# Arboricultural Assessment 445-467 Blackburn Road, Mount Waverley

Prepared for Just China Holdings

Tree Logic Ref: 8319

7/06/2017

**Figure 2:** An excerpt of the current design, showing the proposed construction within the TPZ of Tree 15.

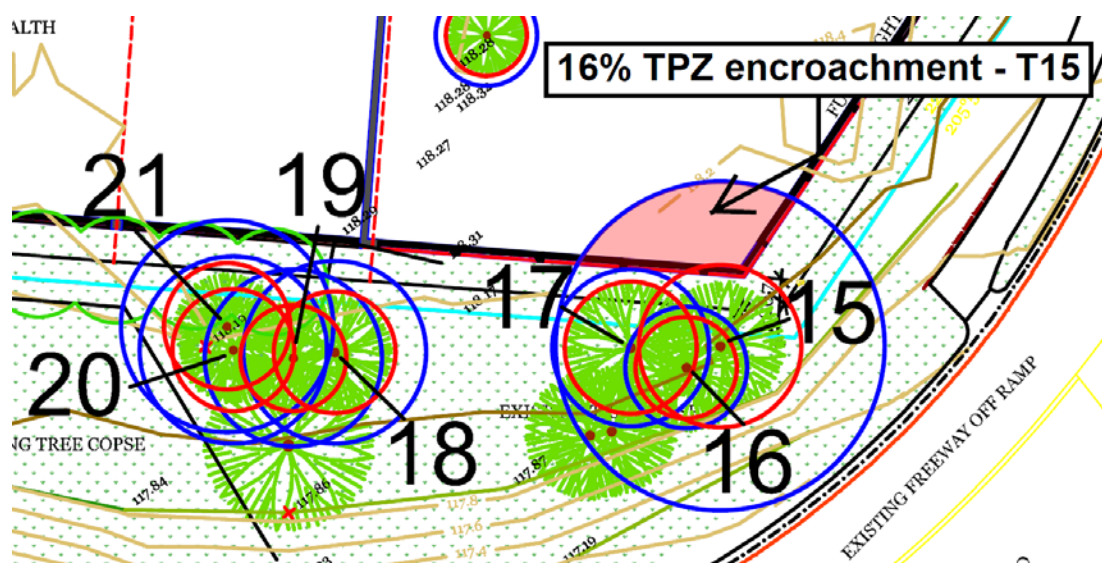
Shown in Figure 2, the footprint of the proposed Common Entry Foyer extends into the 6.5 m radius TPZ of Tree 15 by approximately 22 square metres or 16%. Tree 15 was an over-mature specimen that displayed poor structure and was in the process of collapsing. The proposed 16% TPZ encroachment is likely to be inconsequential to the ongoing demise of the tree.

- 5.3 To successfully retain the suitable trees, tree protection fencing and management must be implemented prior to commencing any construction related activity including demolition, bulk earthworks and landscaping. TPZ fencing must be erected:

- 5.3.1.1 Along the south eastern boundary to protect the TPZs of Trees 15 – 21.  
Appropriate tree protection management is required to be established 1 metre back from the proposed building footprint with appropriate ground buffering installed between the TPZ fence and the building, where the footprint exists within the trees' allocated TPZs.

**Appendix 2: Tree location plan and impact assessment: 445-467 Blackburn Road, Mount Waverley.**

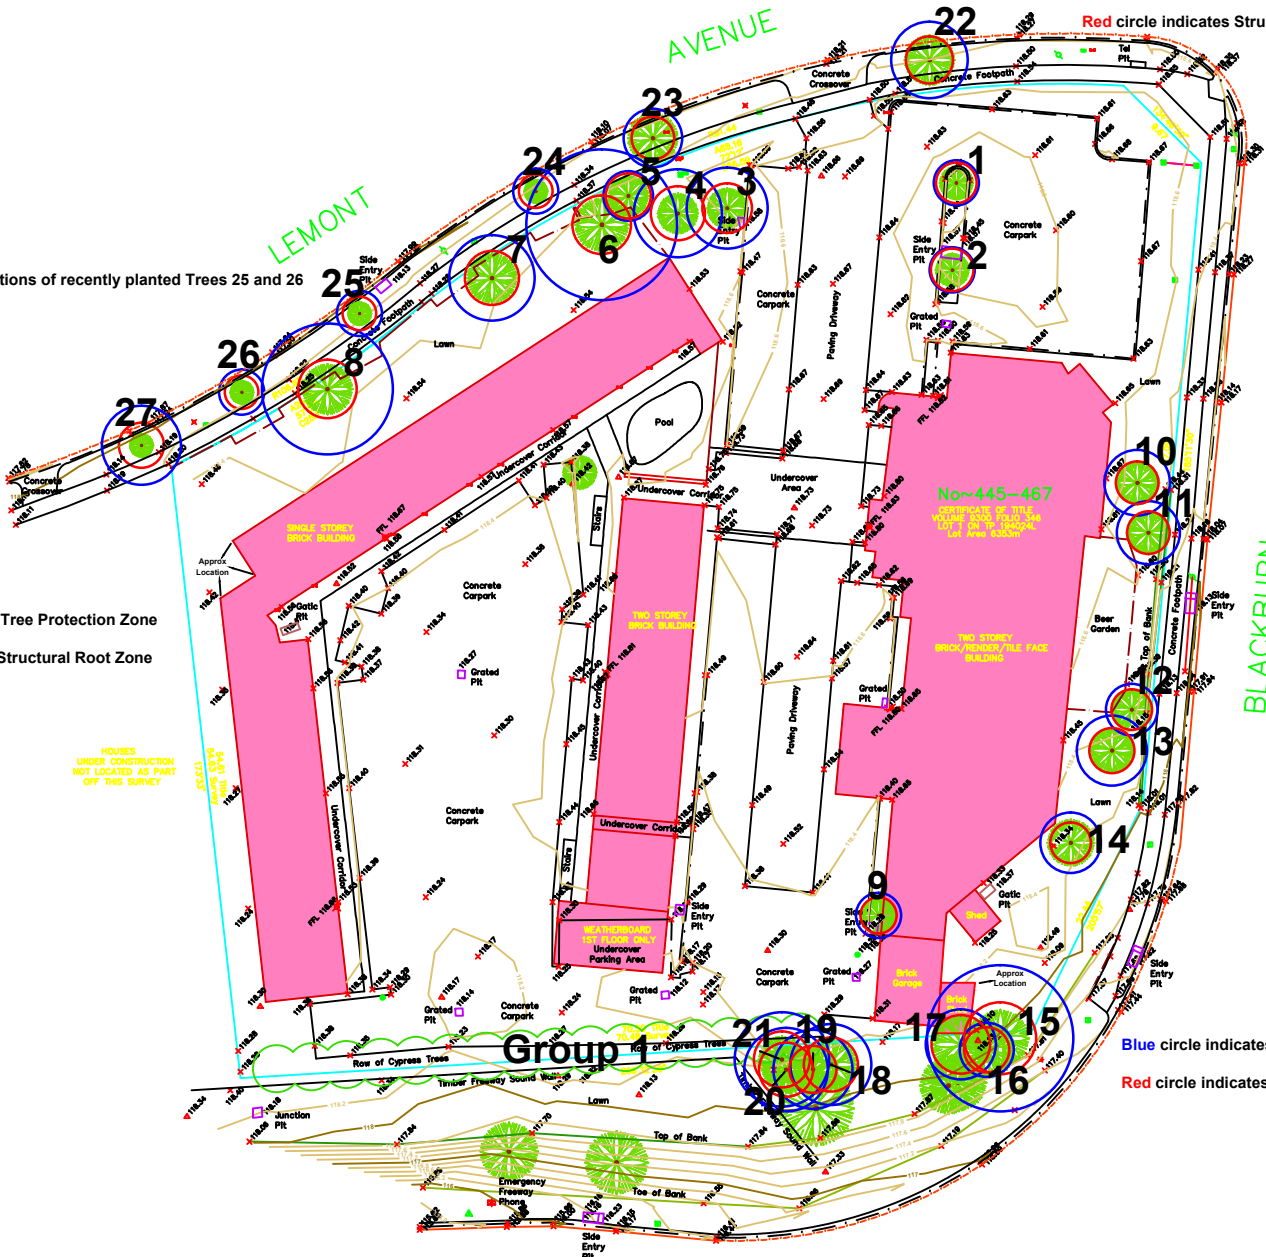
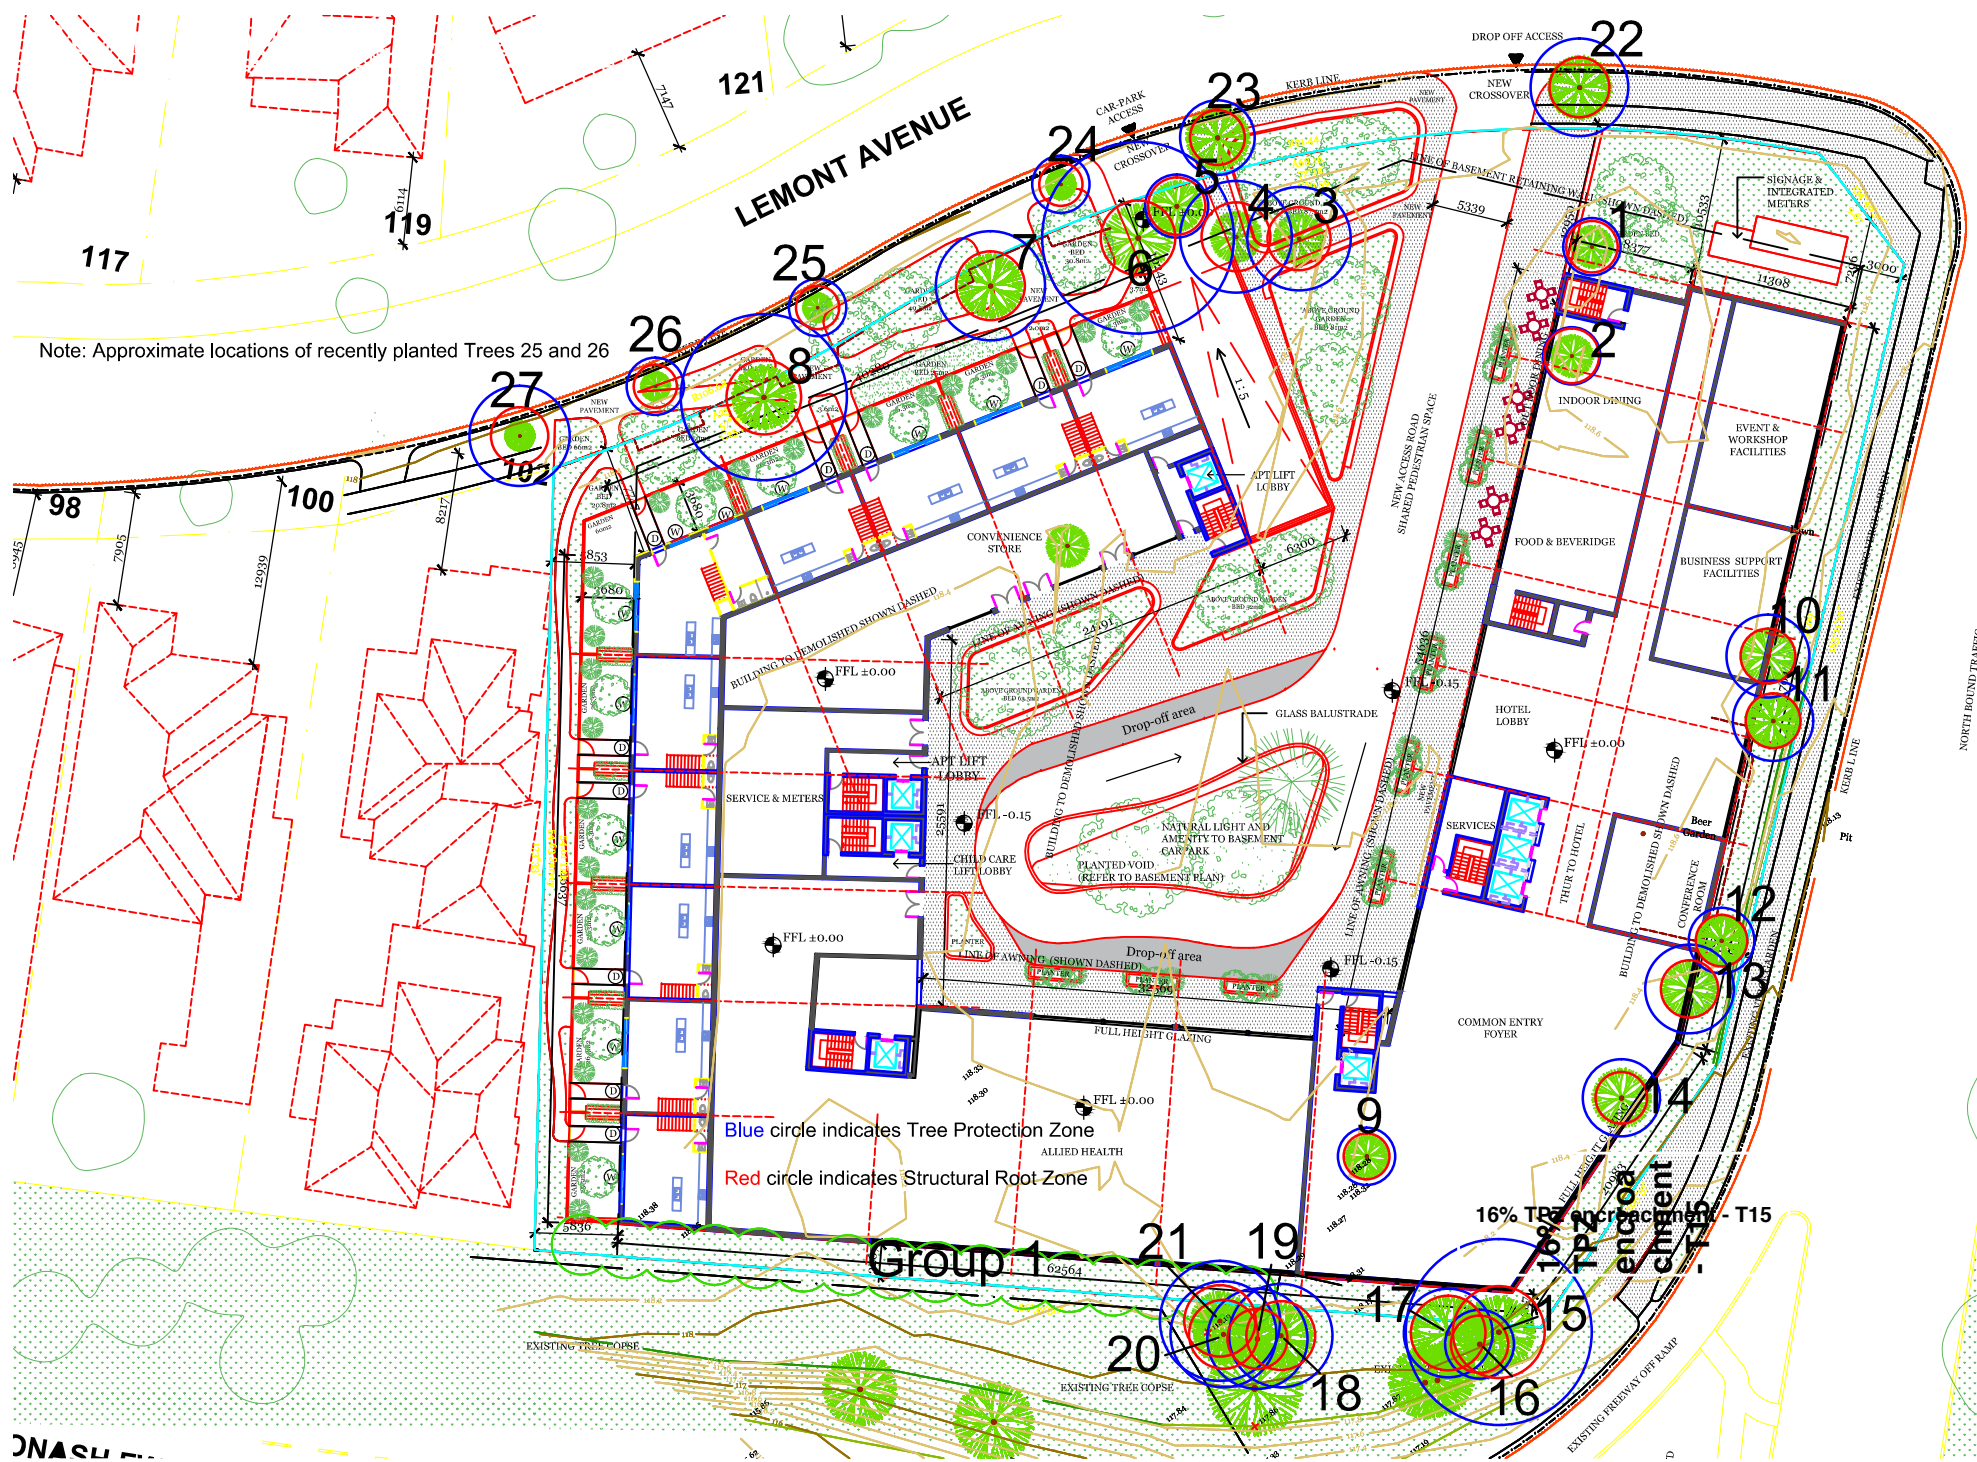
16% TPZ  
18% TPZ  
end area  
chamber - T15
